16 MRS N-TRUCK

23 APR 94

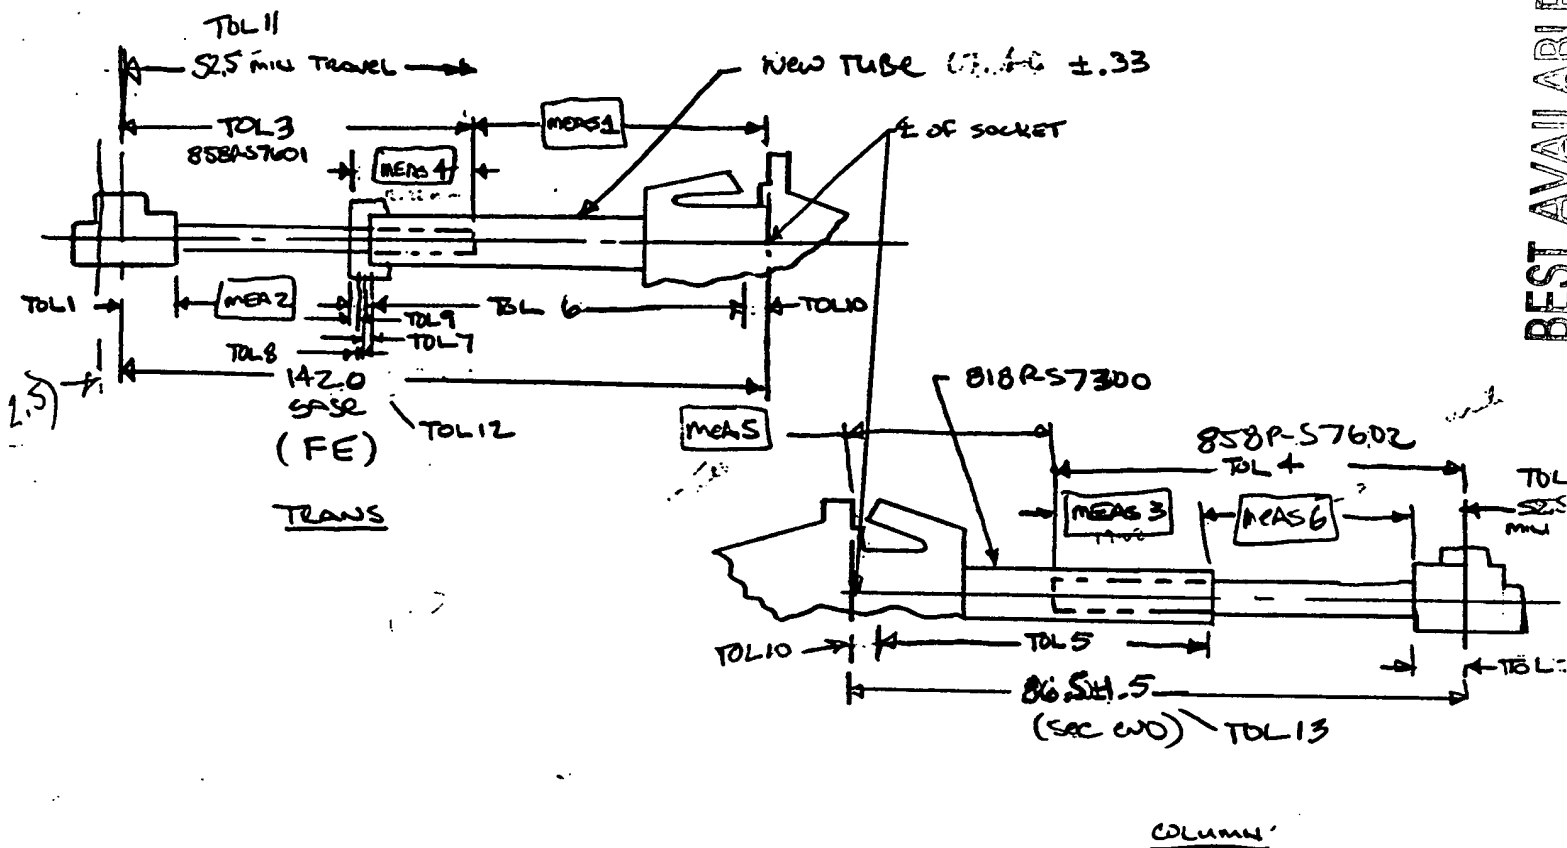
- 1) GRAB LENGTH 142 ± 1.5 ONLY TOL 12
- 2) TRAVEL 52.5 = APPROX 52.38

145 TRANS AT 86.5 COLUMN

Make 147 + 2.5 OVERLAY

1) 142 ⇒ 145

2) USE 1.0 TIME FOR EACH BUT 2.0 or 2.1 each

3) COLUMN END IS 86.5 NOT 140.0 TRAVEL PLUS 52.

4) ADD LEADING GROWTH

5) AFTER OVER SHOOT SEE END SAY 7.0 MIN BUT NOT
BE THAT CORRELATE TO IN MID-COORD.

6) 22 = 203 RANGE!

7) SNAP-IN PROBE DESIGN!!

8) SYSTEM IN SHIPPING

9) NEED 500 mm FROM TRANS END TO MID-COORD
